**SUPERIOR CHARTER TOWNSHIP PLANNING COMMISSION
SUPERIOR TOWNSHIP HALL
3040 N. PROSPECT, SUPERIOR TOWNSHIP, MI 48198
AGENDA
FEBRUARY 26, 2025 - 7:00 PM**

STPC #25-02 Conditional Use Permit/Preliminary Site Plan - DTE Electric to expand the existing Grenada Electric Substation

DTE Electric Company is seeking approval for a combined Conditional Use Permit and Preliminary Site Plan to expand an existing electrical substation on a 3.76 acres parcel (J -10-18-261-012) located on the east side of Dixboro Road, south of Plymouth Road (see Figure 1). The property is in an Urban Residential District zoned R-4 (Single-Family Residential). The proposed new Grenada Substation would be classified as a "Utility Transmission and Distribution Lines and Pipelines not in Existing Easements or Rights-of-Way" and requires a Conditional Use Permit approval in an R-4 (Urban Residential District).

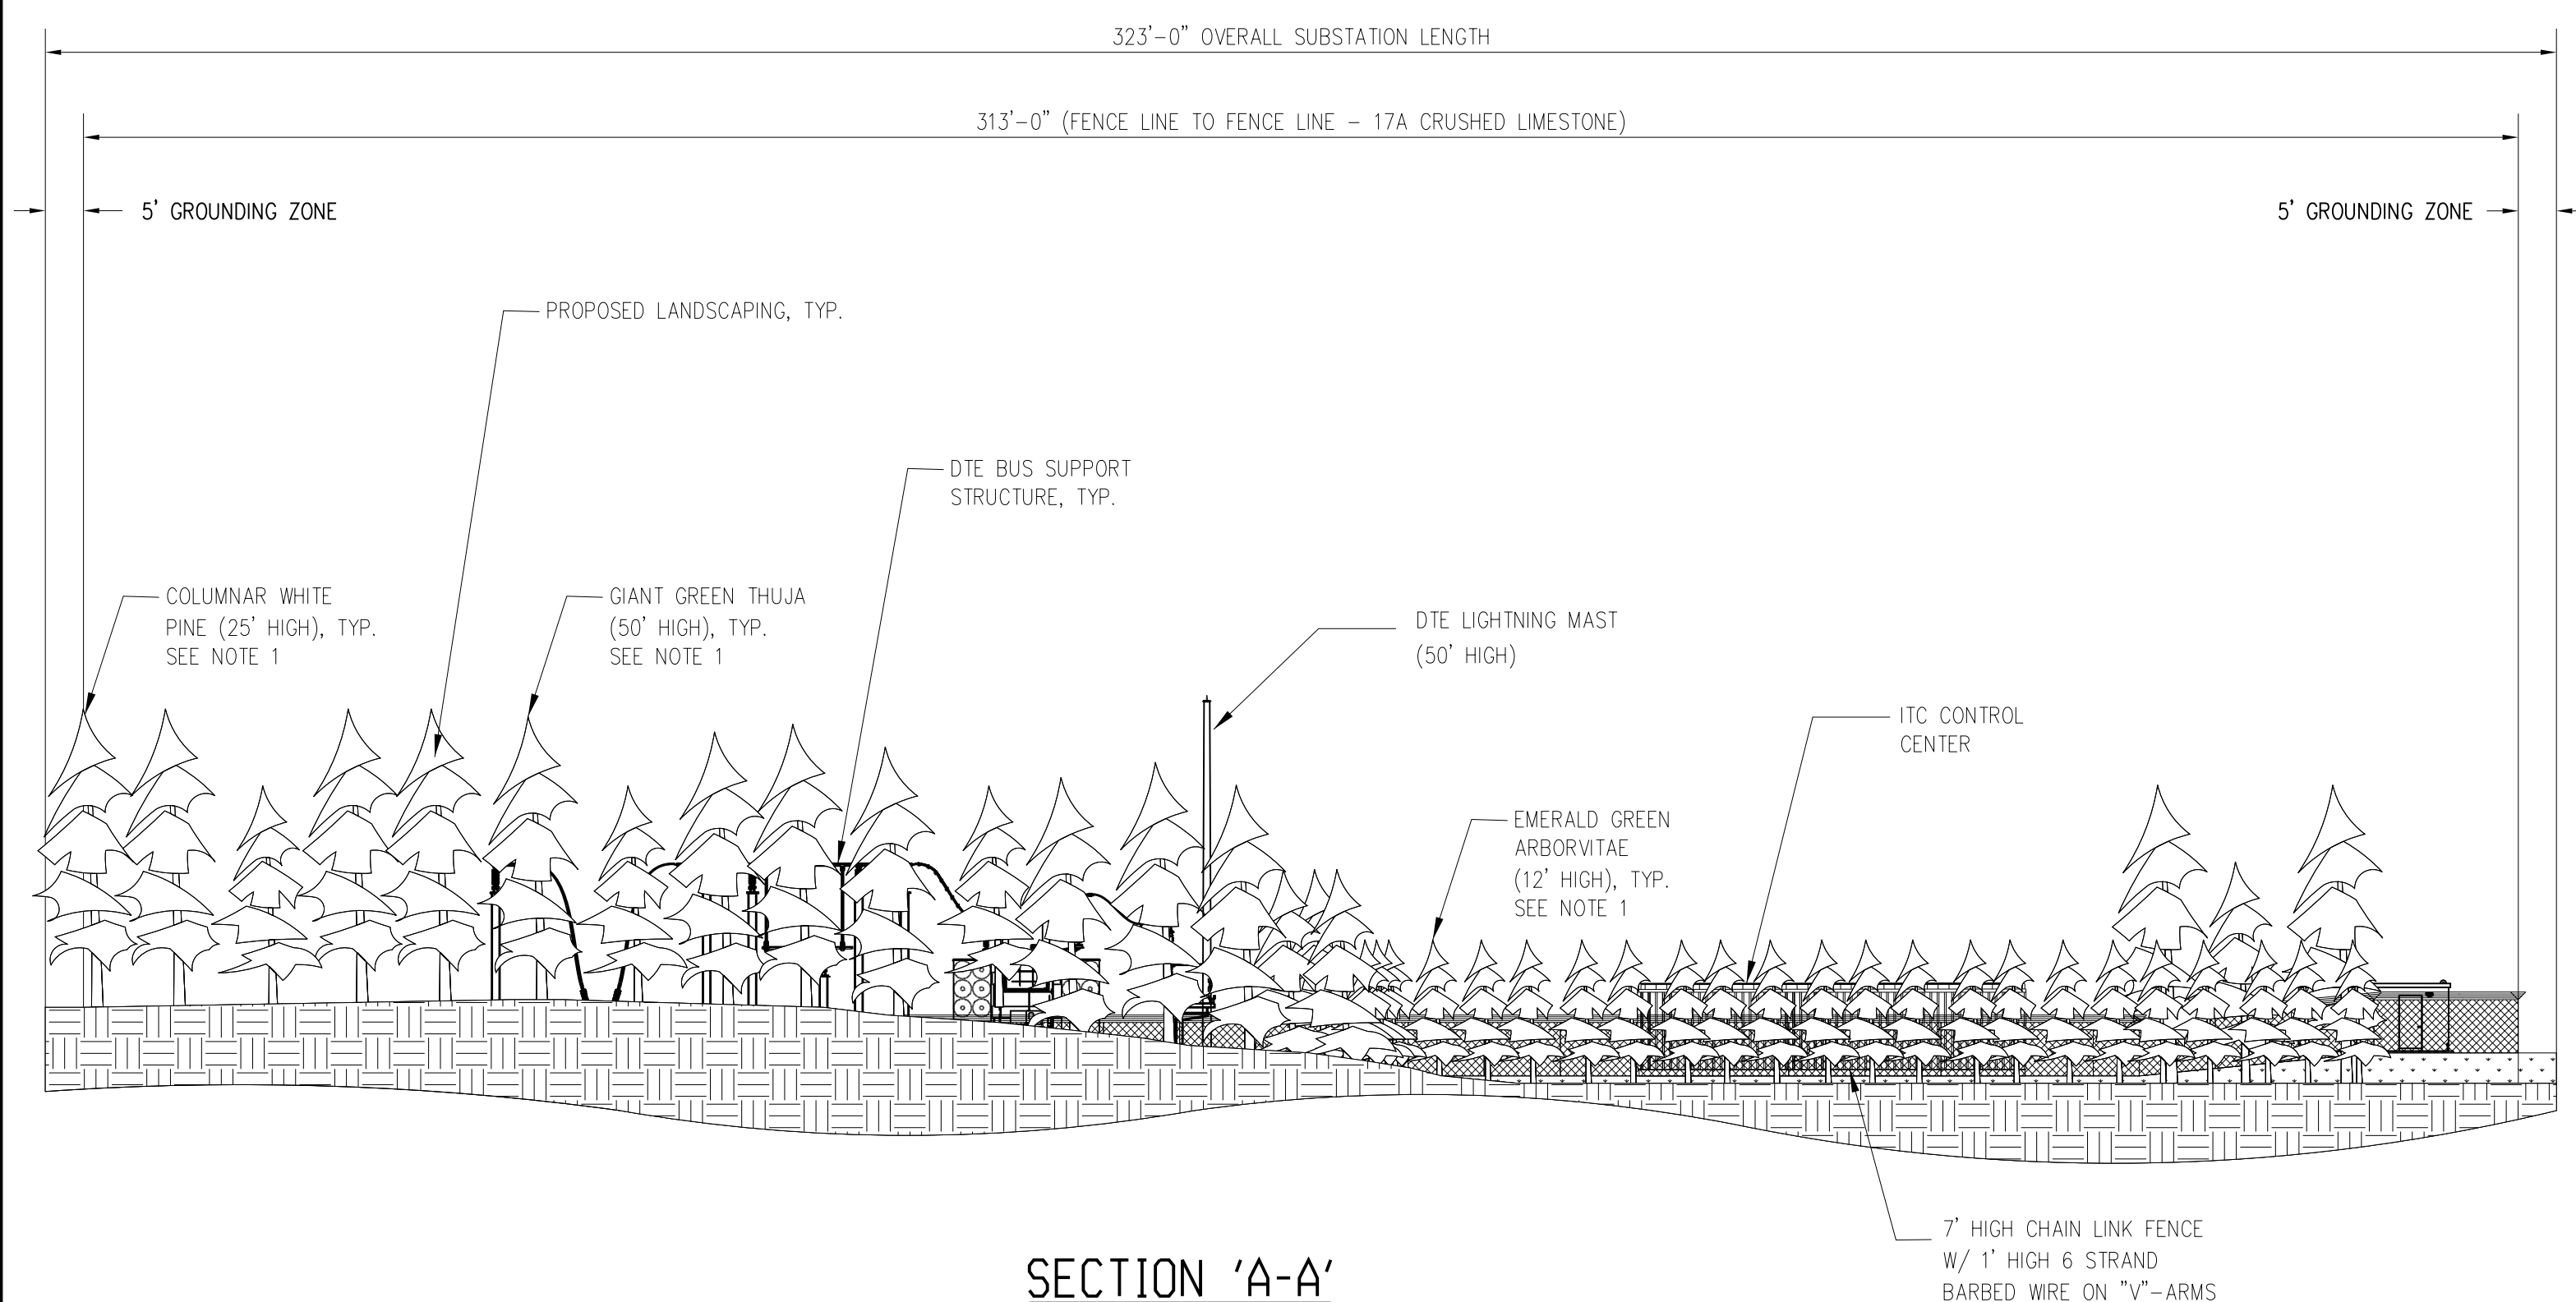
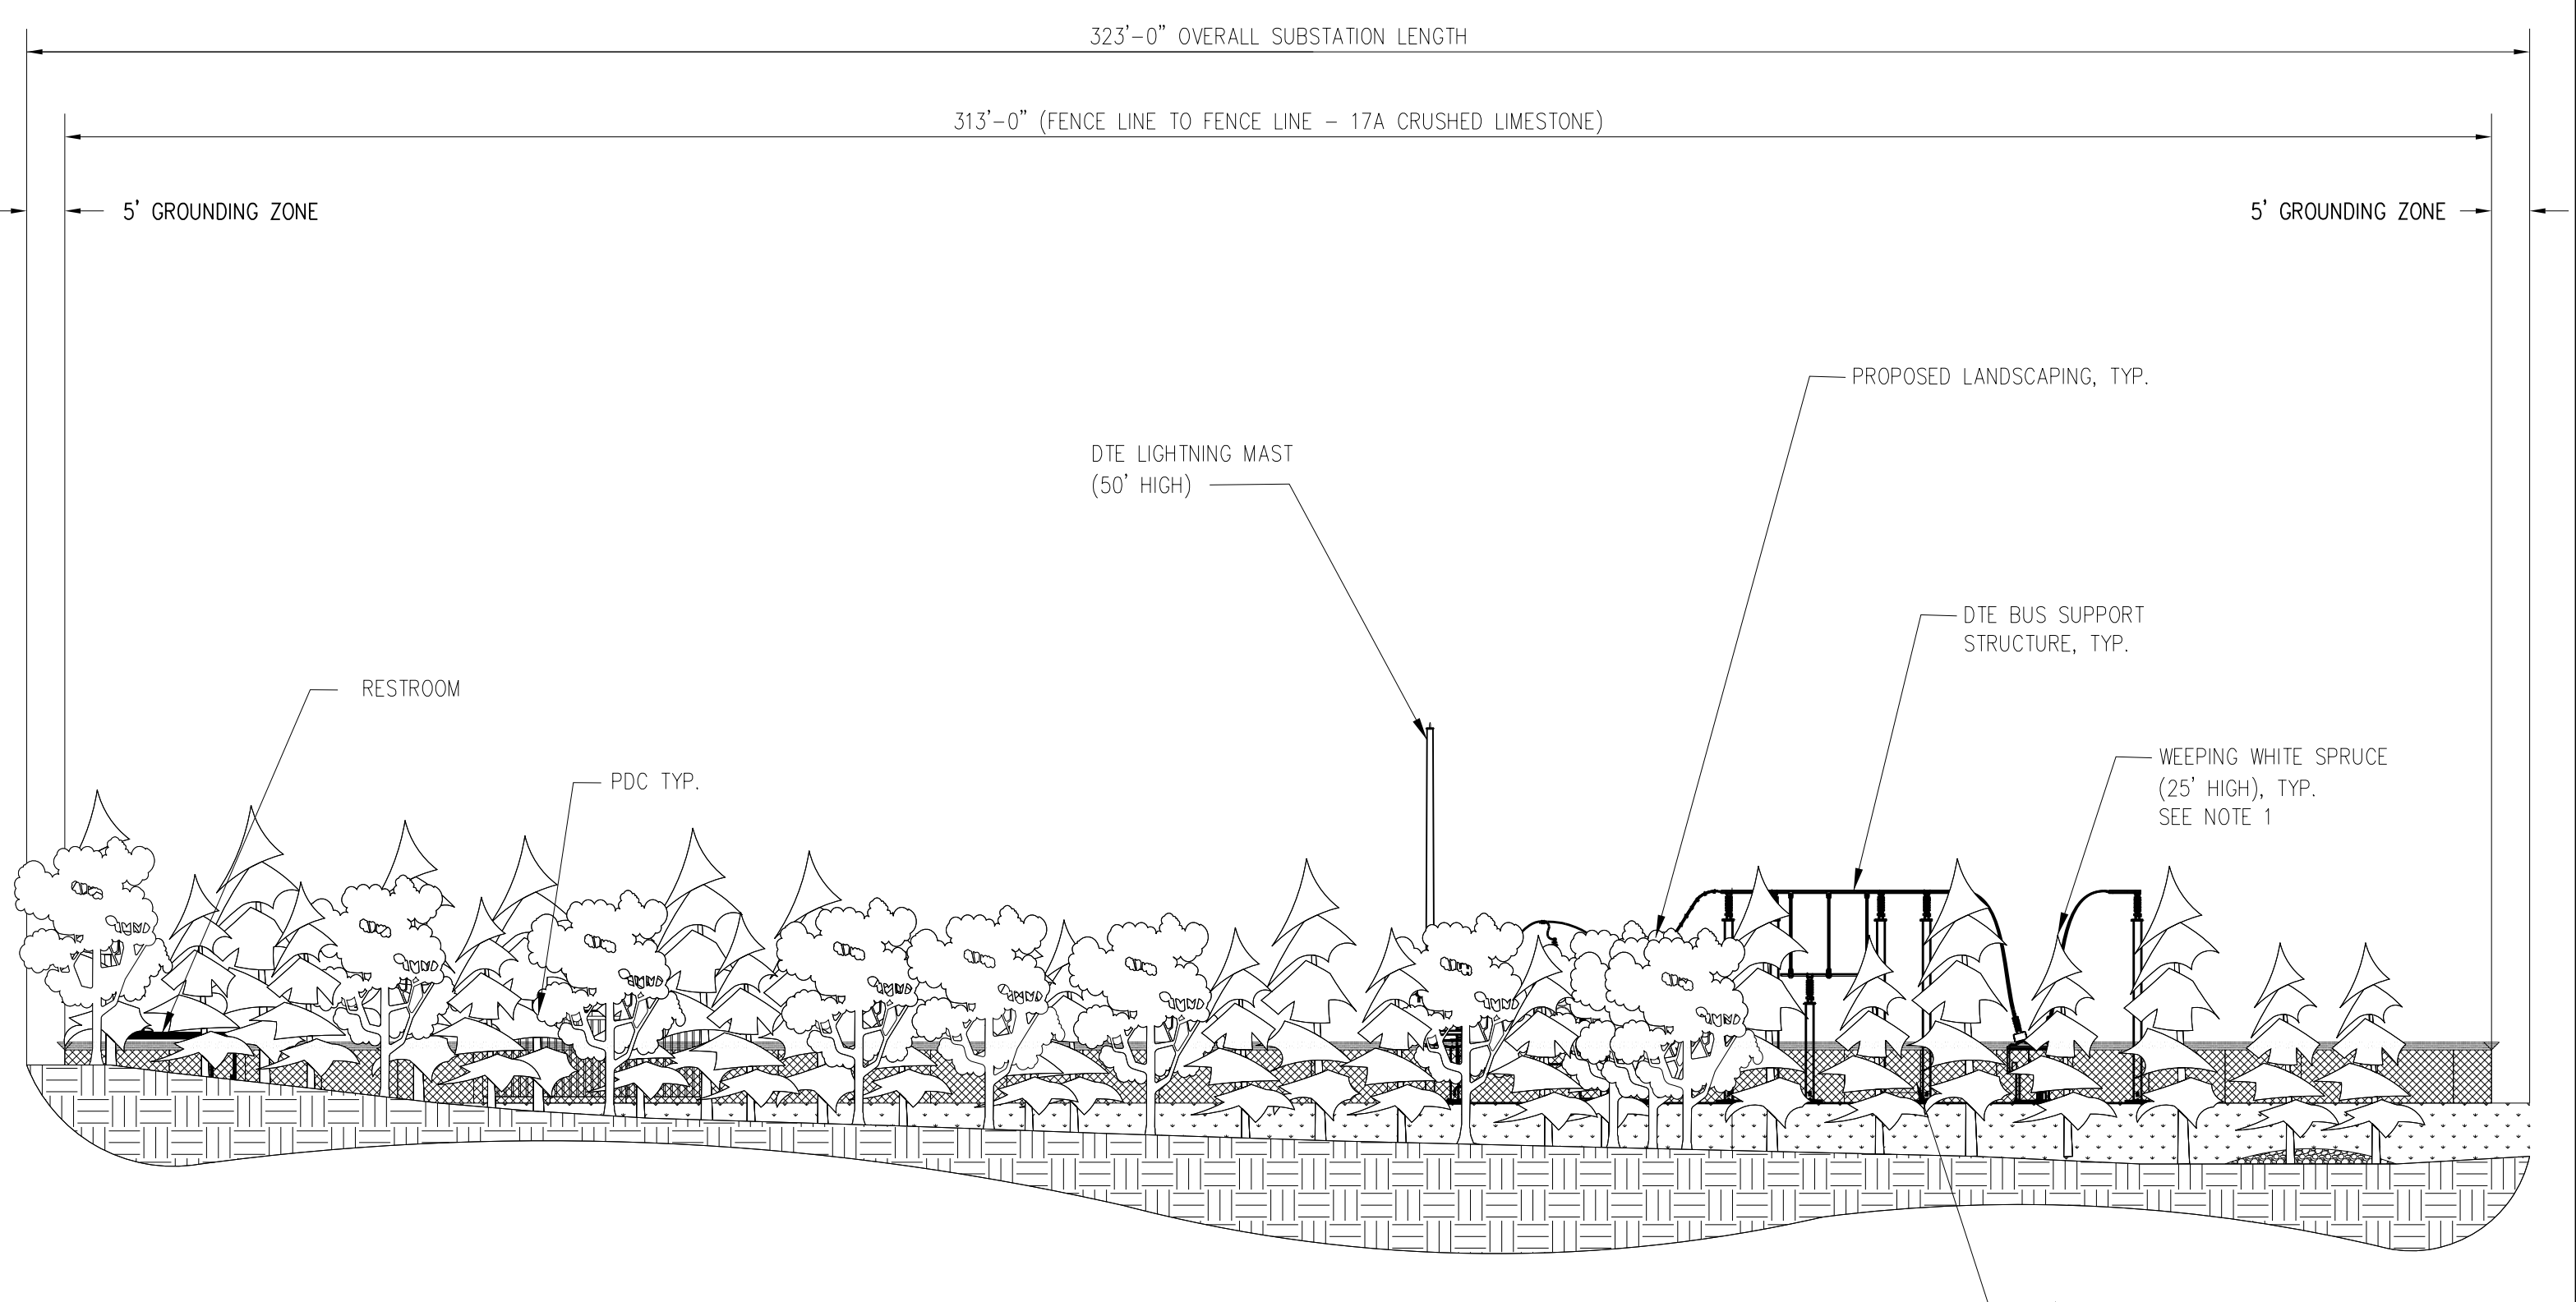
There is an existing substation facility on this property that was constructed around 1990 and the applicant is proposing to improve and expand the facility to improve power reliability in the surrounding areas. The height of the transformer towers proposed was not specified on the plans; however, they appear to be less than the 50 foot high lightning masts shown on sheet 5A1329-10 (Substation Elevations & Section Views).

The Planning Commission may require additional plantings to achieve the screening objectives of Section 14.10D; however, based on a review of substation elevations and section views shown on sheet 5A1329-10, the substation should be adequately screened after landscape reaches full maturity. Furthermore, the substation pad will be at 817 finished grade which is almost 10 feet below the grade of Dixboro Road and there is a natural berm towards the northeast corner of the property.
